L-PI-04-129
10 CFR 50.90

Prairie Island Nuclear Generating Plant Units 1 and 2
Dockets 50-282 and 50-306
License Nos. DPR-42 and DPR-60

License Amendment Request (LAR) to Revise the Spent Fuel Pool Criticality Analyses and Technical Specifications (TS) 3.7.17, "Spent Fuel Pool Storage" and 4.3, "Fuel Storage"

License Amendment Request (LAR) to Revise the Spent Fuel Pool Criticality Analyses and Technical Specifications (TS) 3.7.17, "Spent Fuel Pool Storage" and 4.3, "Fuel Storage"

FIGURE 4.3.1-10 Spent Fuel Pool Checkerboard Region Burnup and Decay Time Requirements—STD Fuel, 12 GAD

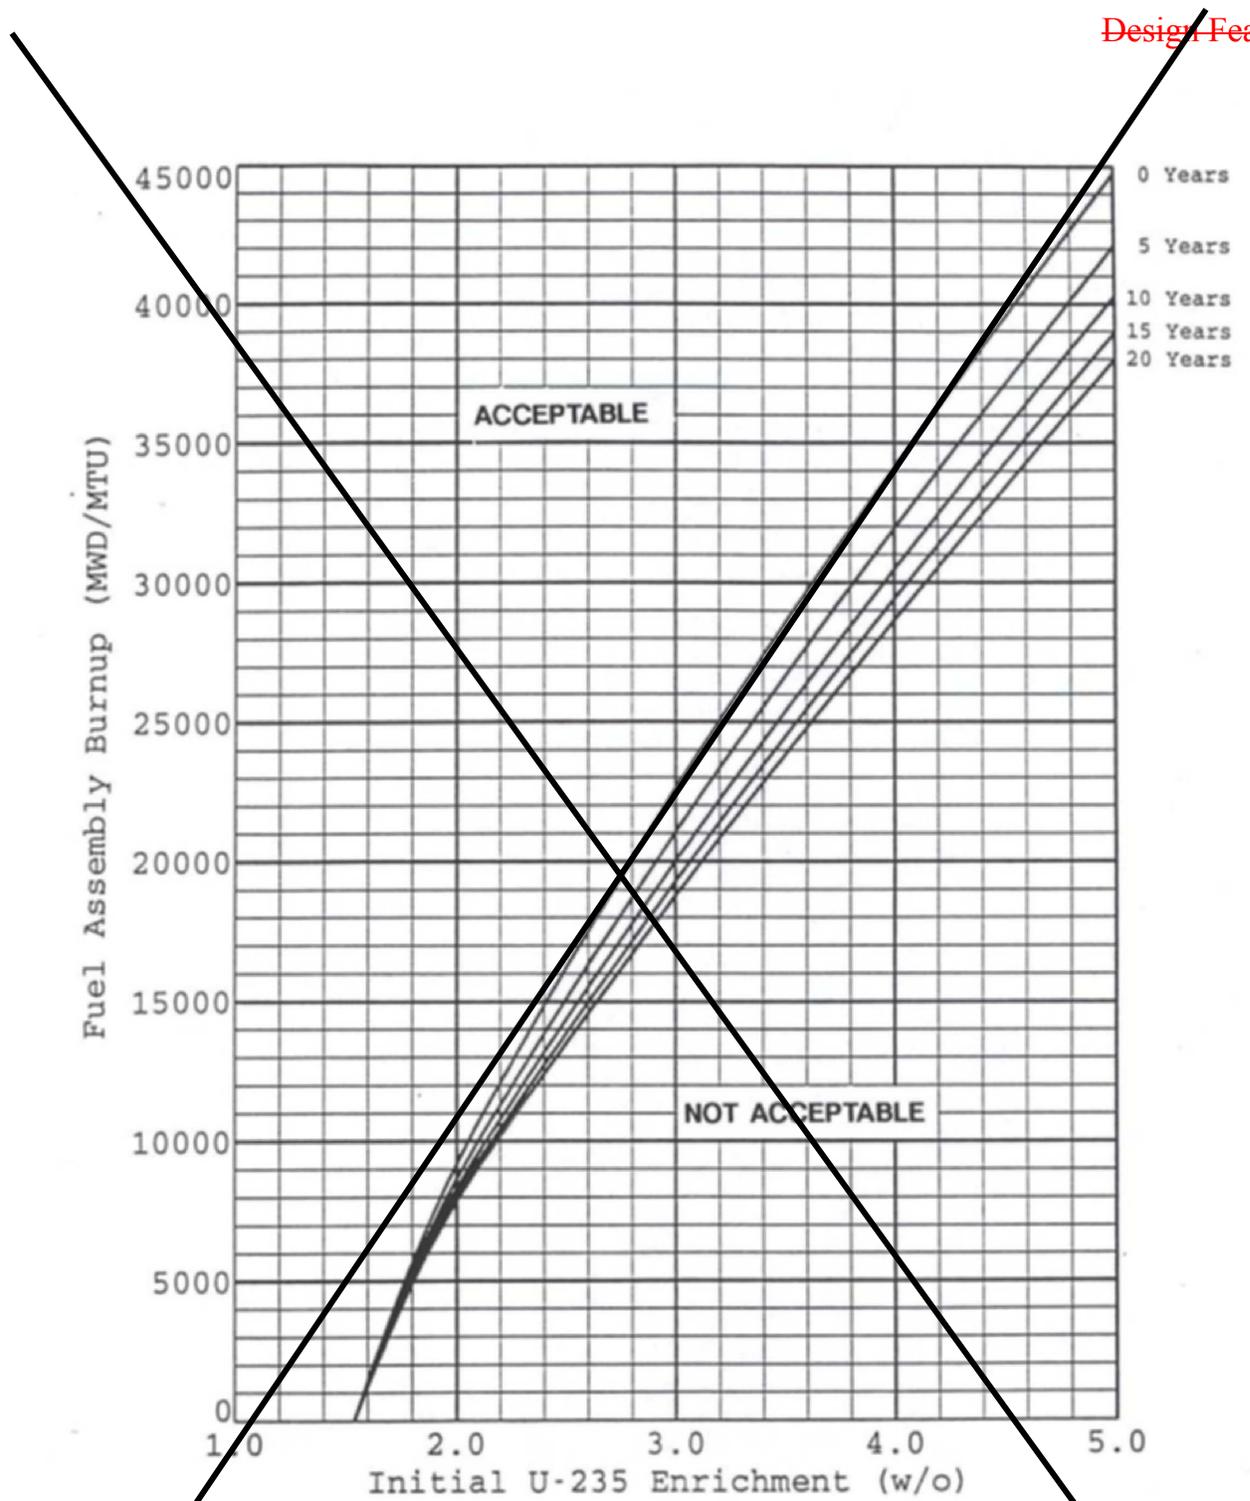
Figure deleted

FIGURE 4.3.1-11 Spent Fuel Pool Checkerboard Region Burnup and Decay Time Requirements—OFA Fuel, 16 or More GAD

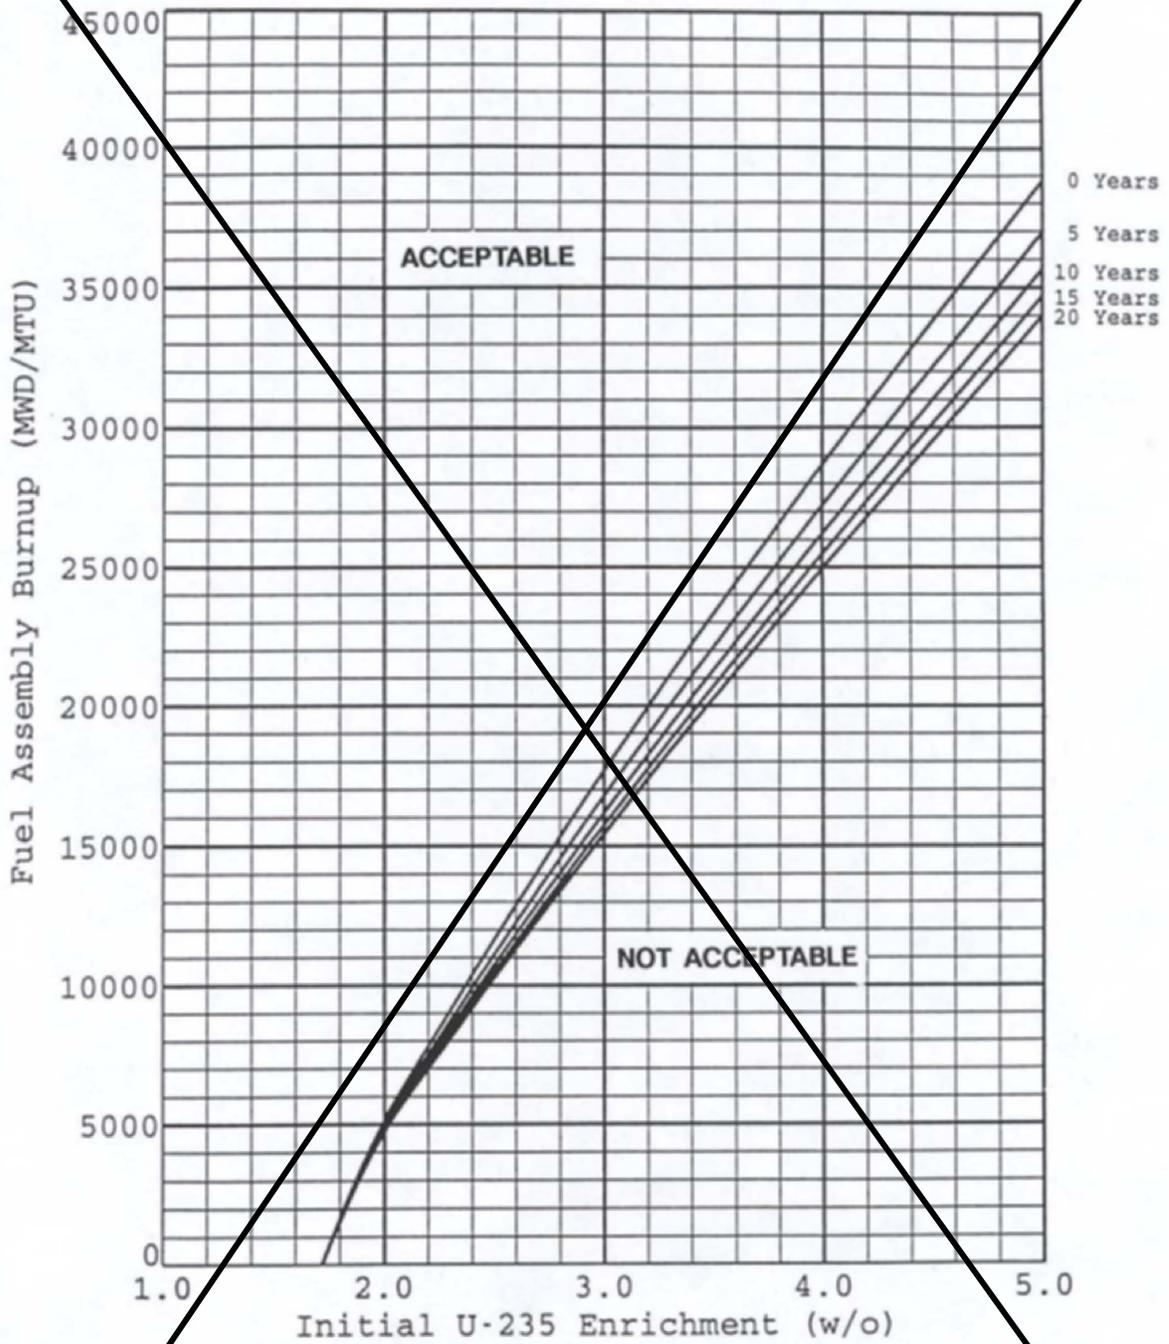
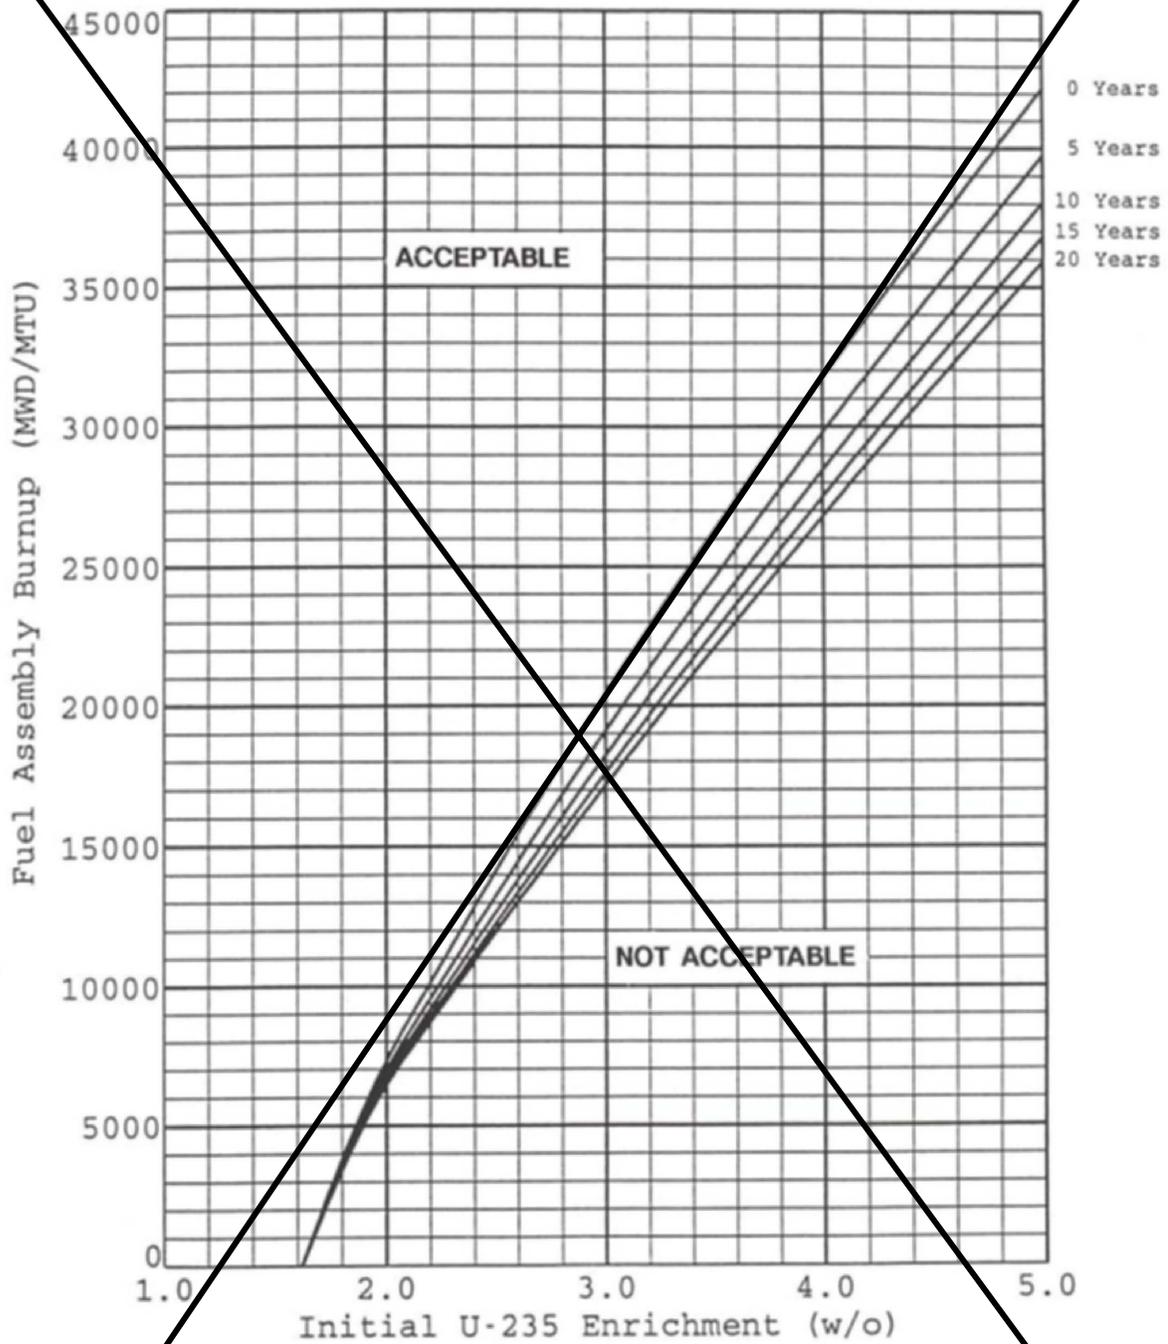
Figure deleted
